GGG-S-1408A
INTERIM AMENDMENT-2
April 20, 1976
SUPERSEDING
Int. Amendment-1
March 6, 1974

INTERIM AMENDMENT

FEDERAL SPECIFICATION

SCREWDRIVER, RATCHET, RIGHT ANGLE OFFSET,
RIGHT AND LEFT HAND TURNING

FIGURE 4. Type II, class 3, screwdriver bit, crosspoint (Reed and Prince)

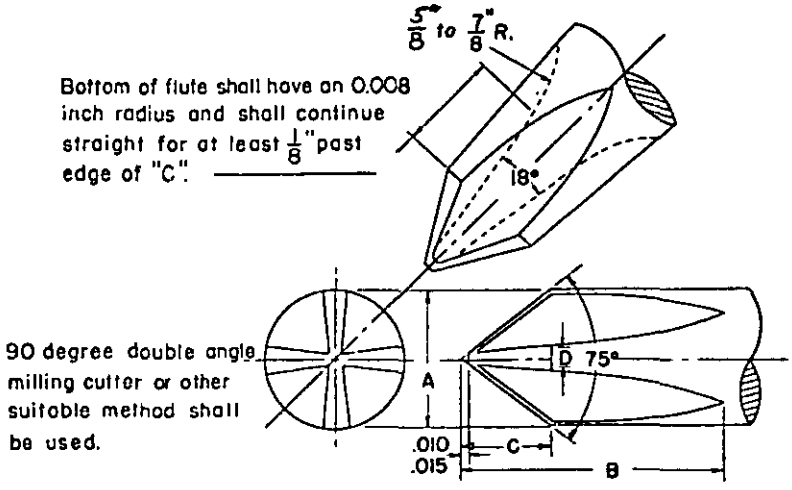
Paragraph 3.7.3, Figure 4, and Table III: Delete and substitute:

"3.7.3 Type II, class 3, crosspoint (Reed and Prince). Class 3 bits shall have hexagonal bodies conforming to the requirements in 3.7 and bit ends similar to figure 4. Dimensions and torsional requirements shall be as specified in table III for the size specified (see 6.2).

TABLE III. Class 4, crosspoint bits (Reed and Prince)

TIP SIZE (Inch)	HEXAGON BODY SIZE (Inch)	B (Inch)	C (Inch)	D (Inch)
1/4	1/4	9/16	0.163	0.050
5/16	1/4	5/8	0.204	0.060
